## PROPOSED CHANGE NOTICE

2445-24

**RE:** AURORA FOOD STORE  
2000 ANAQUOD ROAD  
REGINA, SK  
Commission No. 2445

**RE:** Canopy Overhang

**Item # 1** **High Parapet Overhang**  
**Instigation:** Design Continuation  
**Reference:** RFI #038

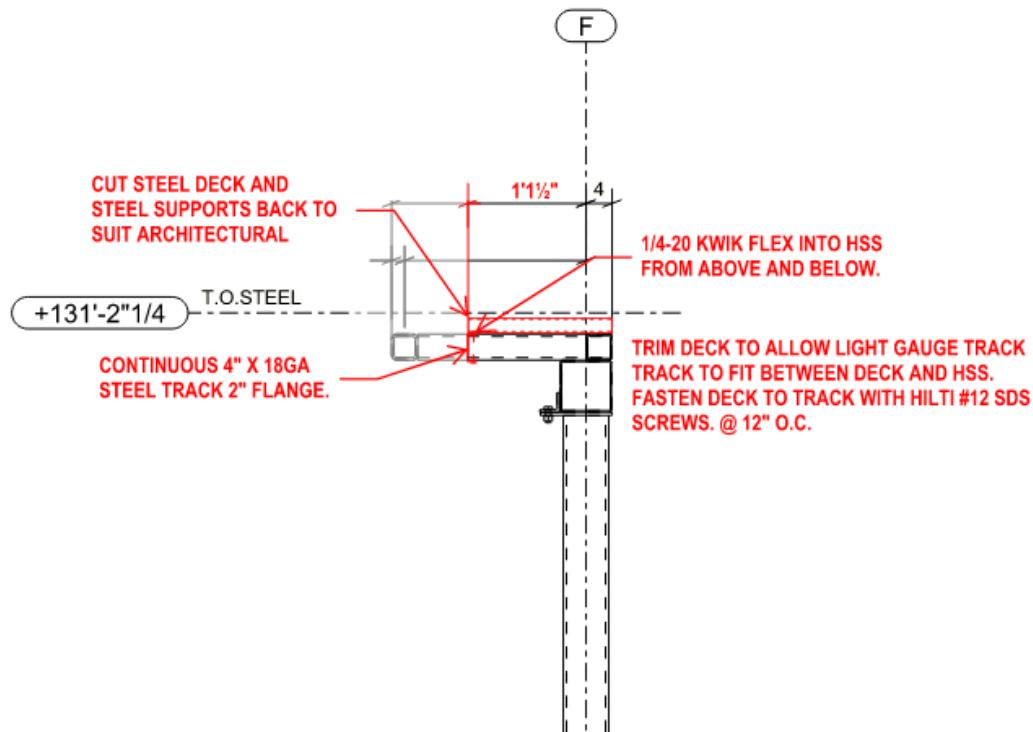
a) Steel overhang to be cut back to suit architectural details.  
b) Repair steel as per detail below:

Drawings # A4.0/1, S2.4/5; A5.0/3

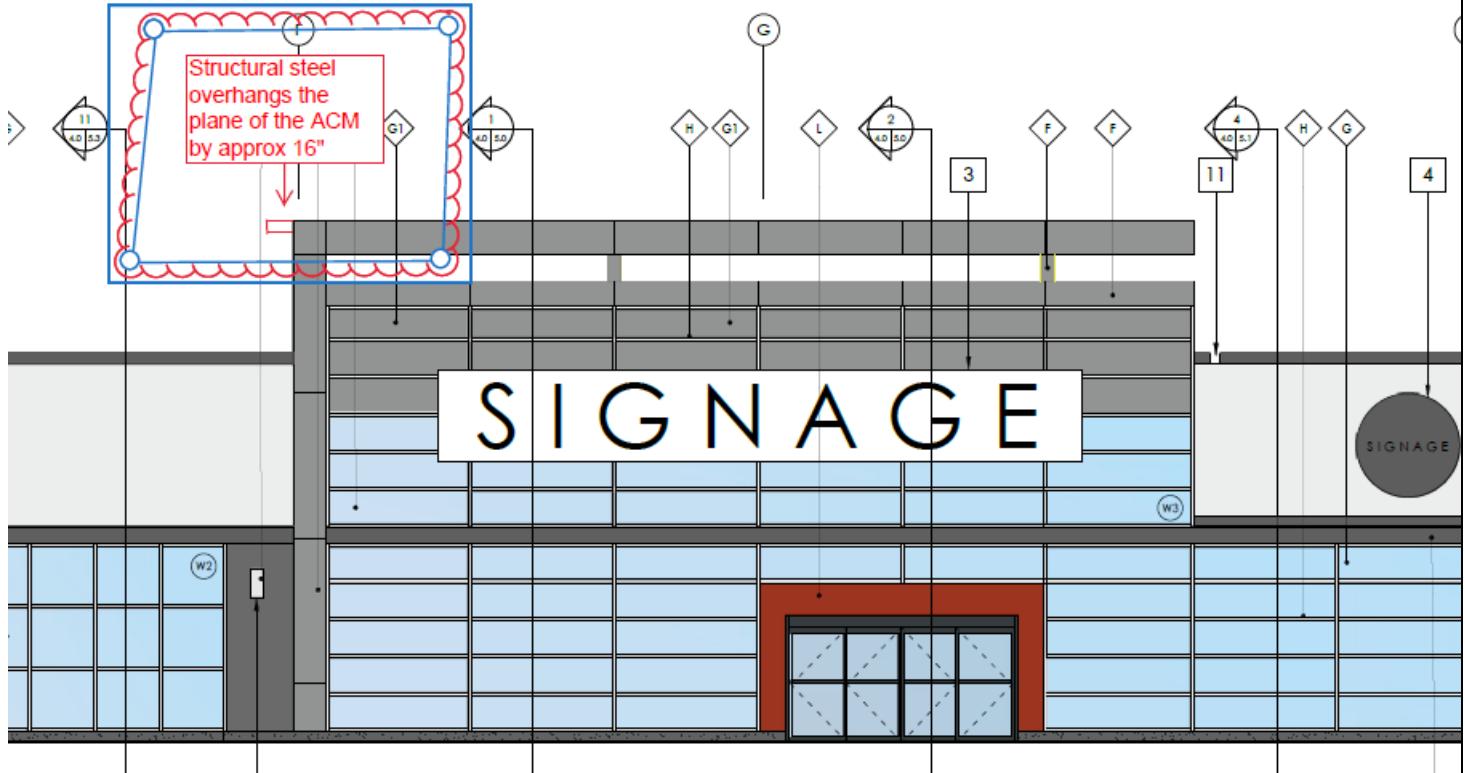
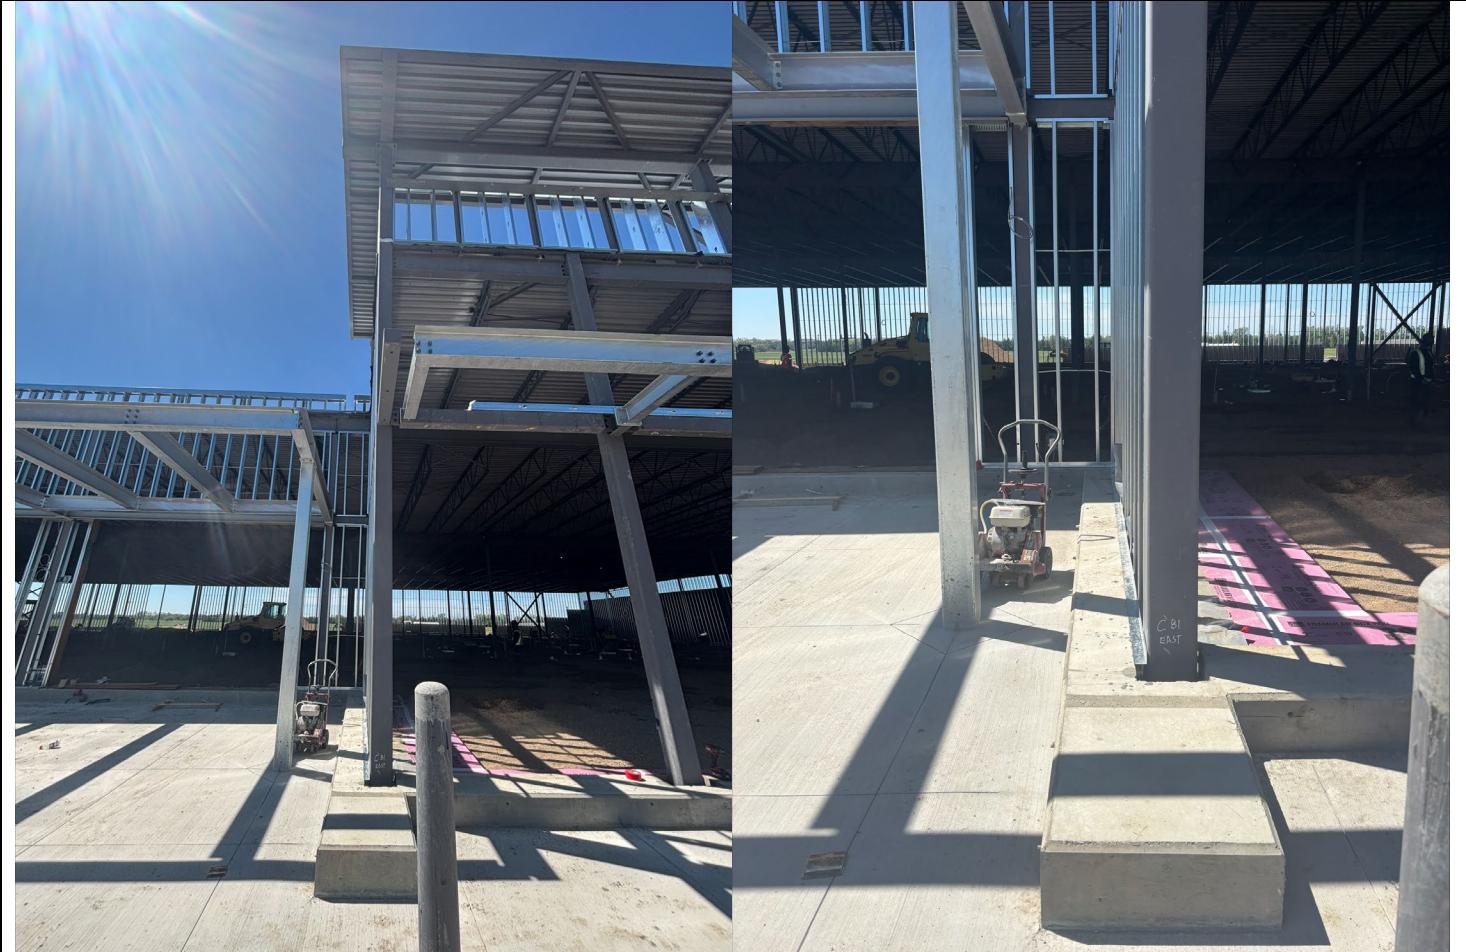
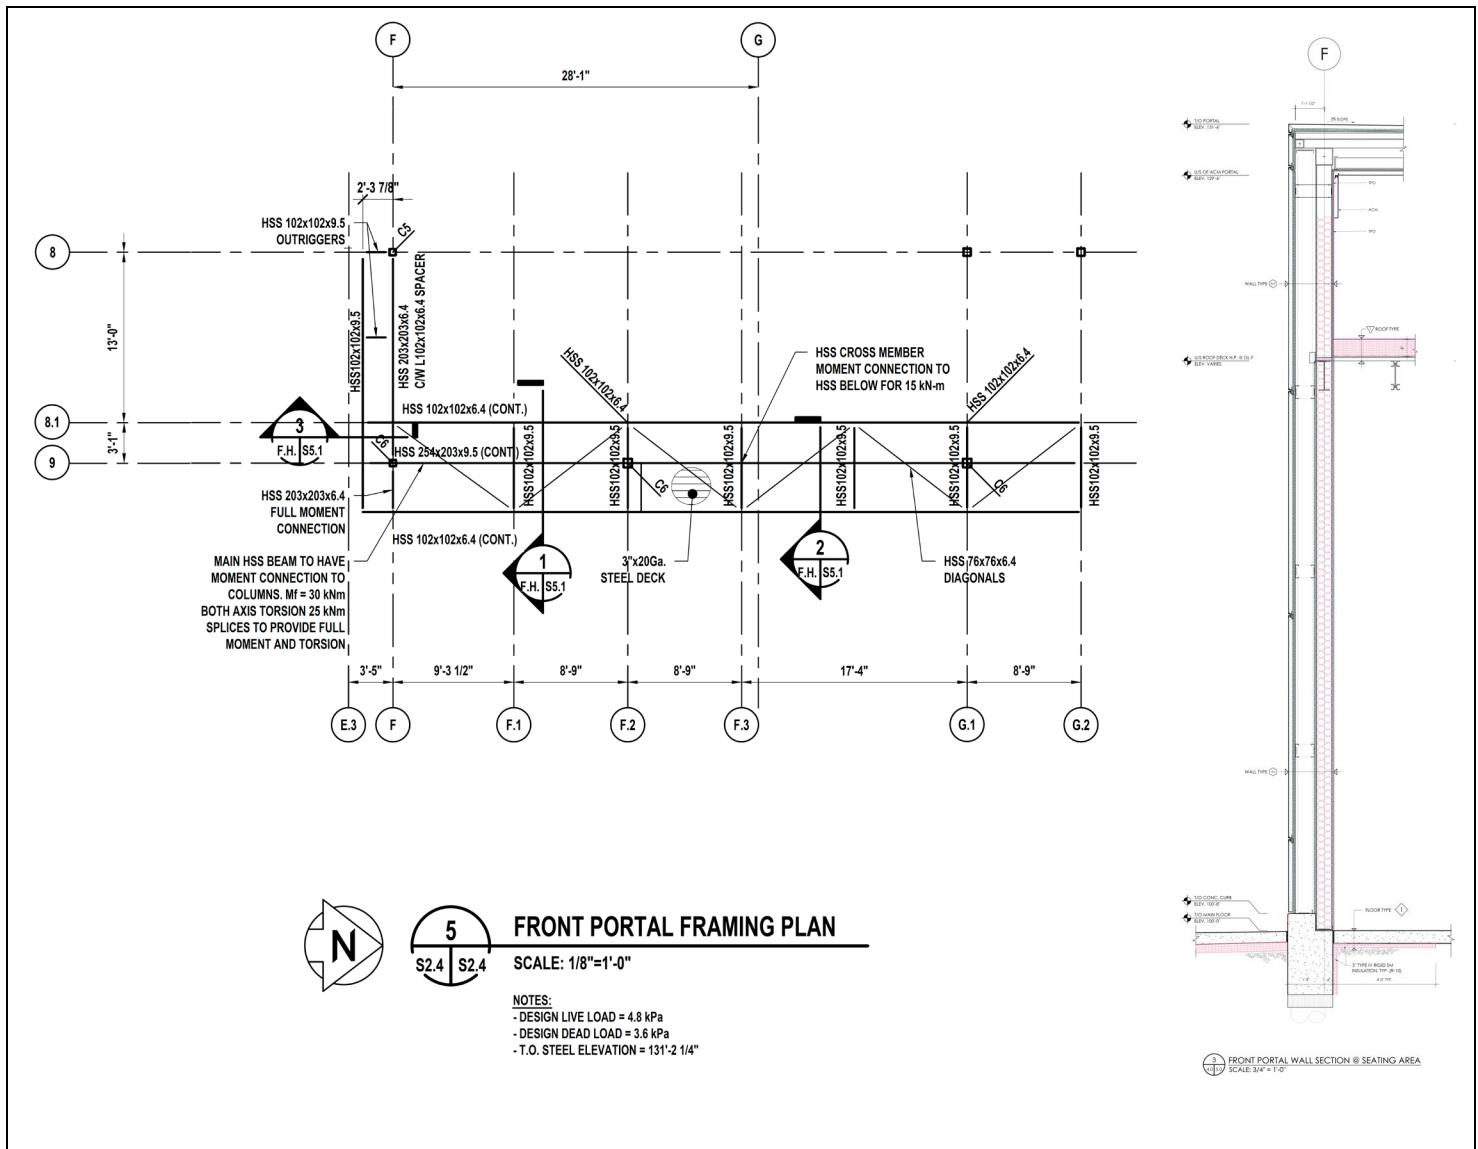
- 1) The very top cap of the canopy overhangs to the south too far. It overhangs the outside sheathing of the ACM build out by approx. 16". On drawing S2.4 detail 5, the front portal framing detail shows the overhang is 3'-5" past grid line F. On drawing A5.0 section 3, the outside of the steel stud wall is shown to be 1'-1 1/2" of grid line F. How are we to proceed?

Overhang to be cut back to suit architectural.
